PennEast Pipeline Company, LLC
One Meridian Boulevard, Suite 2C01
Wyomissing, PA 19610

Re: PennEast Pipeline Company, LLC, Docket No. CP15-558-000
Responses to DEIS Recommended Conditions

Responses to Draft Environmental Impact Statement Recommended Conditions

Figure 1: Coal Seam Cross Section at Susquehanna River Crossing

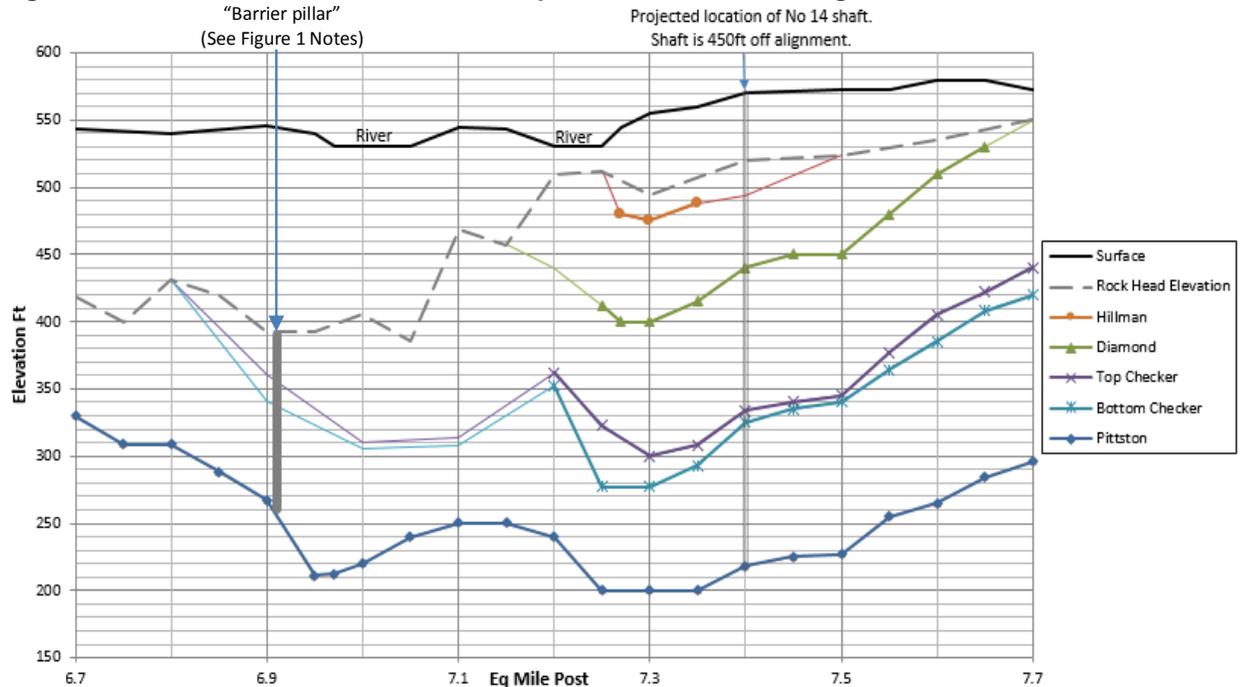
Prior to the end of the draft EIS comment period, PennEast shall file with the Secretary the results of its ongoing evaluation of potential presence of working and abandoned mines near the proposed crossing of the Susquehanna River. The evaluation shall include documentation of coordination with the Pennsylvania Bureau of Abandoned Mine Reclamation, and shall identify any specific design or mitigation measures. (*Section 4.1.5.4*)

Figure 1 displays a cross section of coal workings beneath the alignment near the Susquehanna River. The depth to rock head was obtained from inspection of coal exploratory borehole notes. At Project milepost (MP) 7.25, the Hillman coal seam intersects the top of rock at an elevation of approximately 510 feet; however, at this location it should be noted the seam is not worked. The closest worked coal seams occur at Project MP 7.27. At this location the workings of the Hillman seam lay at approximately 65 feet below the surface. Approximately 40 feet of this cover is surficial deposits, in addition to 25 feet of rock cover.

WORKSPACE CONFIGURATION FOR CATEGORY ONE WATERBODY DRY CROSSING TYPICAL

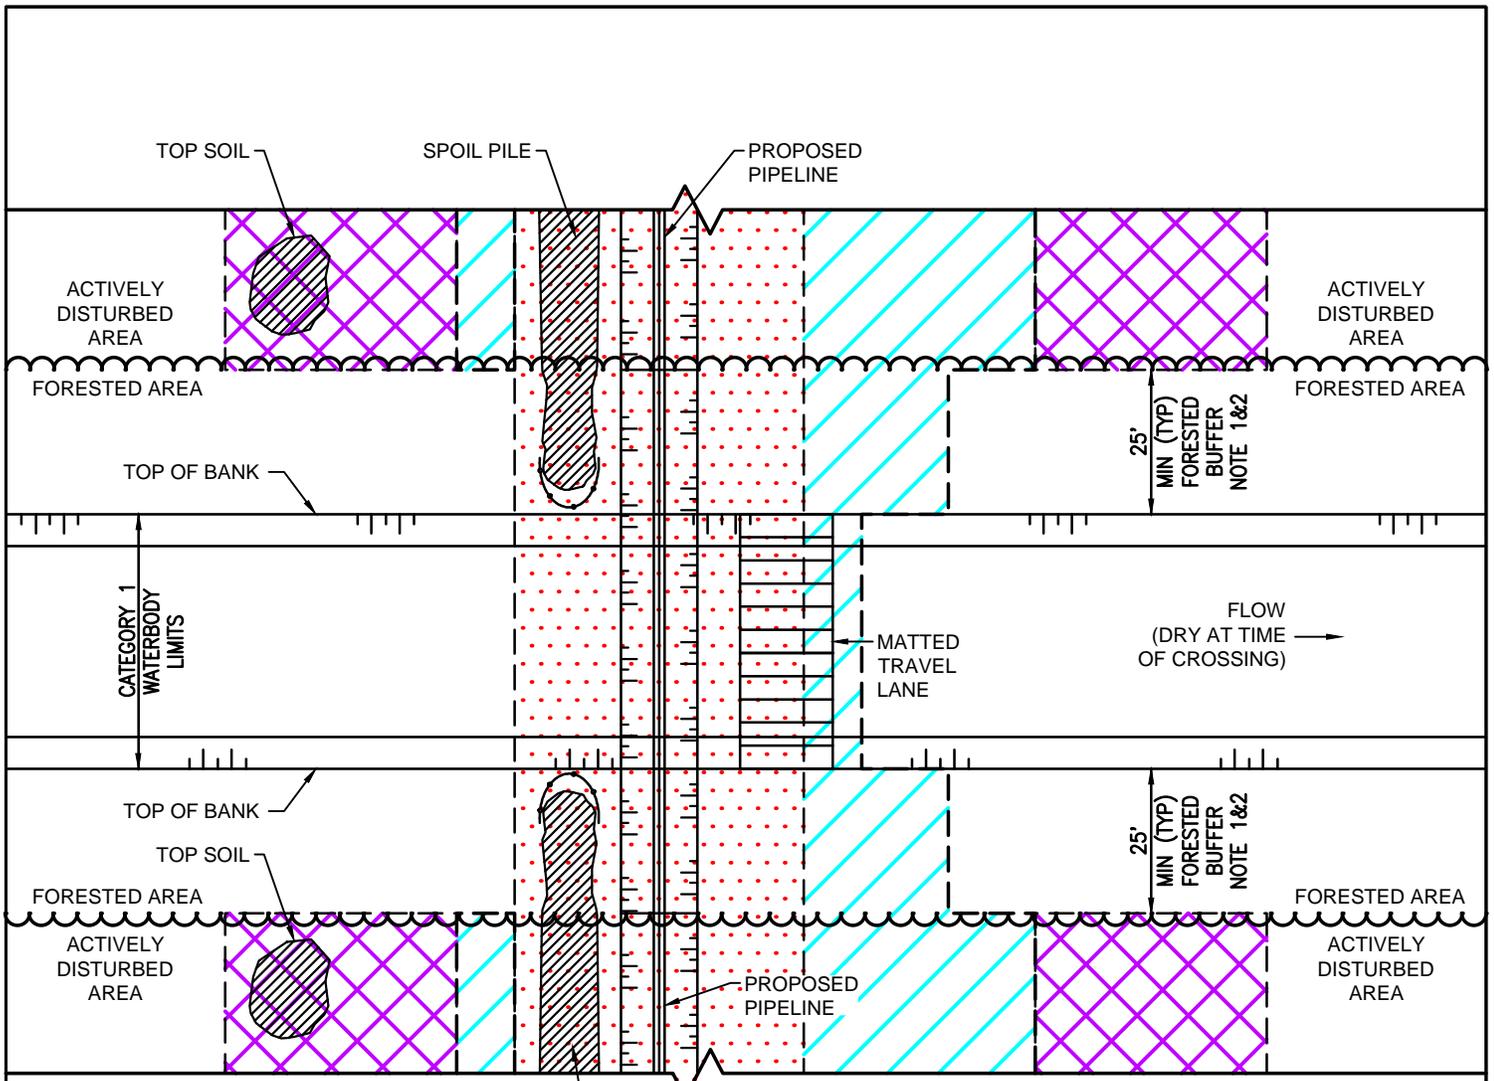
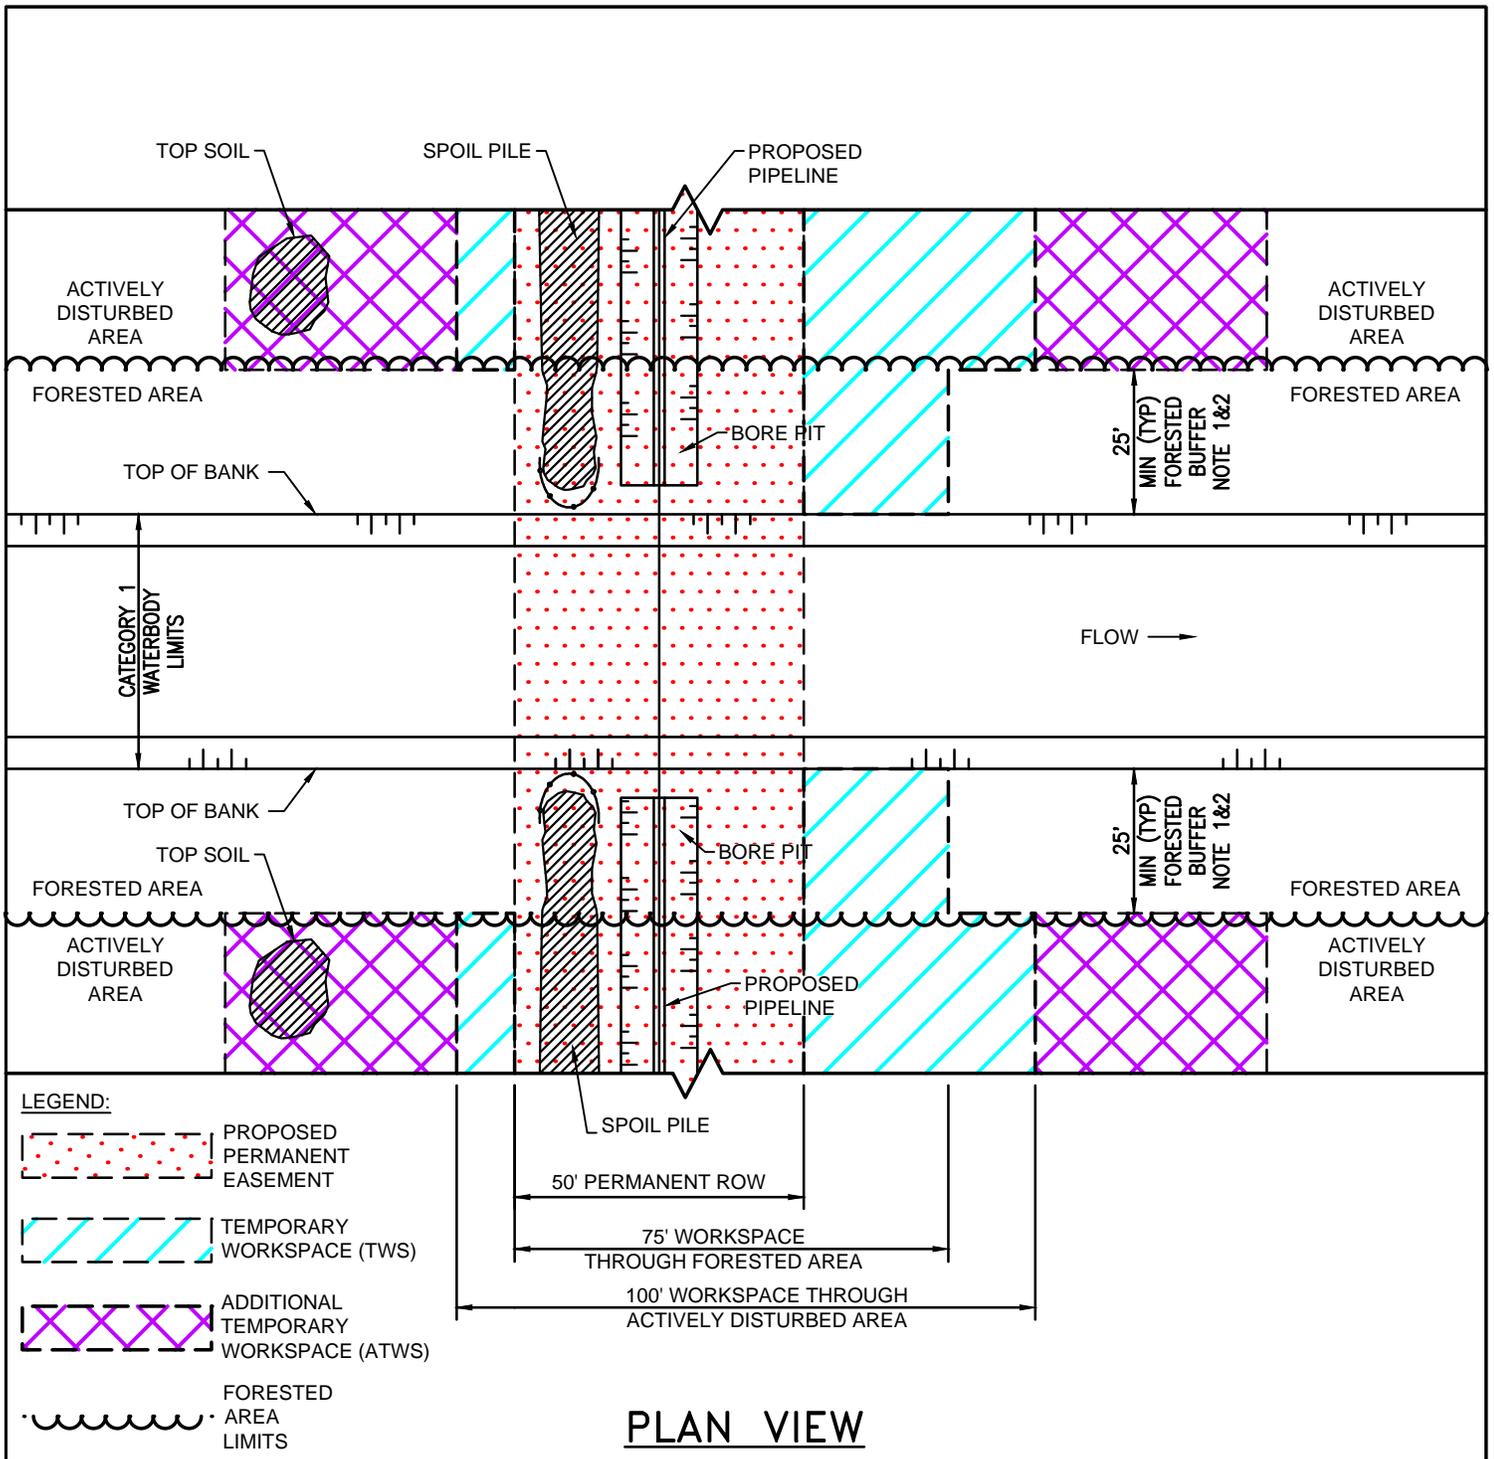
Prior to the end of the draft EIS comment period, PennEast shall file with the Secretary documentation to identify any special construction procedures that will be implemented to minimize impacts on C-1 streams. PennEast shall provide documentation of consultation with appropriate federal and state agencies regarding C-1 streams, including identification of any agency recommendations and PennEast's responses. (*Section 4.3.2.2*)

The dry-crossing method would be utilized if streams are located within valleys, or vertical depressions, which are not conducive for trenchless technology. A dry-crossing will consist of reducing the workspace through the waterbody to a width of 60-feet. This width will be extended through the waterbody and will allow for excavation of the trench materials and placement of a timber mat bridge for equipment crossing. The workspace outside the waterbody will have a total width of 75 feet on both sides of the waterbody until actively disturbed areas are encountered. For a dry-crossing, PennEast will place ATWS for the waterbody crossing in the actively disturbed areas where practicable, and limit the forest clearing to no more than 75 feet wide between the waterbody and actively disturbed areas. Any workspace inside the waterbody will not exceed 60 feet in width. See Figure 1M of Attachment 2 for a typical workspace configuration for dry-crossings of C-1 waterbodies.

Hopewell Township Emergency Services Facility Location Drawing

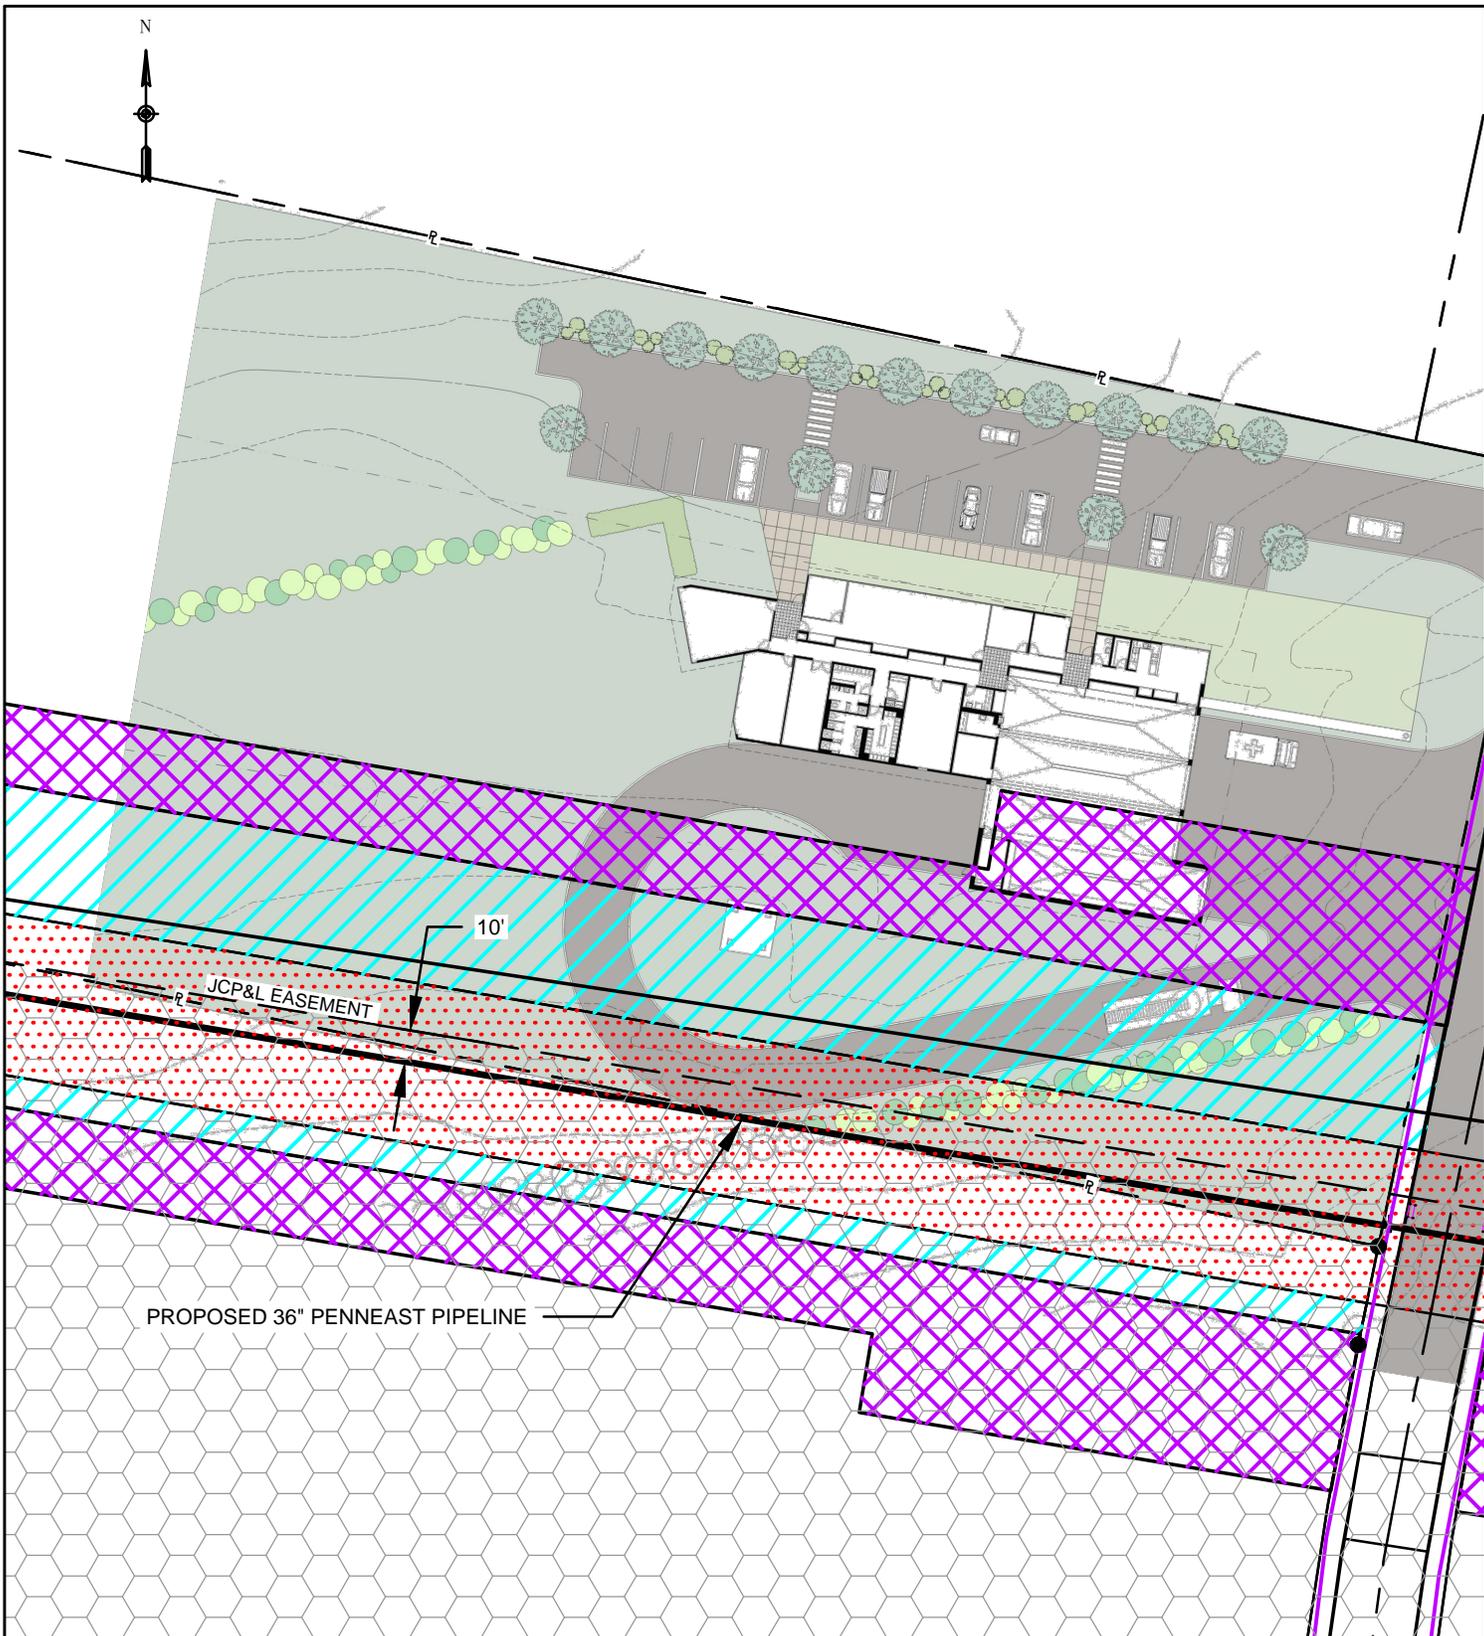
Prior to the end of the draft EIS comment period, PennEast shall file with the Secretary any route adjustments, workspace modifications, or mitigation measures developed through PennEast's ongoing consultations with landowners regarding the following planned and/or pending projects:

Based on the proposed conceptualized sketch of the Emergency Services Facility located on Hopewell Township Tax Block 91, Lot 3.02 filed in this proceeding (FERC accession number 20151215-5202), PennEast is proposing to change the construction method on Lot 3.02 to allow flexibility in the pipeline installation methodology, as depicted in Attachment 5. PennEast has changed the proposed HDD that crossed the CSXT railroad tracts at mile post (MP) 112.3 to be a conventional bored crossing. By implementing this change, workspace flexibility is optimized on Block 91, Lot 3.02. Additionally, PennEast has located the proposed pipeline centerline approximately 10 feet inside an existing powerline easement, thus requiring only 15 feet for a proposed permanent easement outside of the existing powerline easement. PennEast currently has a typical construction workspace configuration across Block 91, Lot 3.02 for pipeline installation. However, if the Emergency Services Facility is constructed before the PennEast Pipeline is constructed, PennEast will coordinate with Hopewell Township to develop a reduction in workspace to minimize disruption to the Emergency Services Facility. This would include, but not be limited to, reducing the temporary workspace and additional temporary workspace to avoid the Emergency Services Facility access driveway and communication tower. Based on the concerns raised by Hopewell Township that PennEast has been made aware of, it is PennEast's understanding that the modifications described above address those concerns.
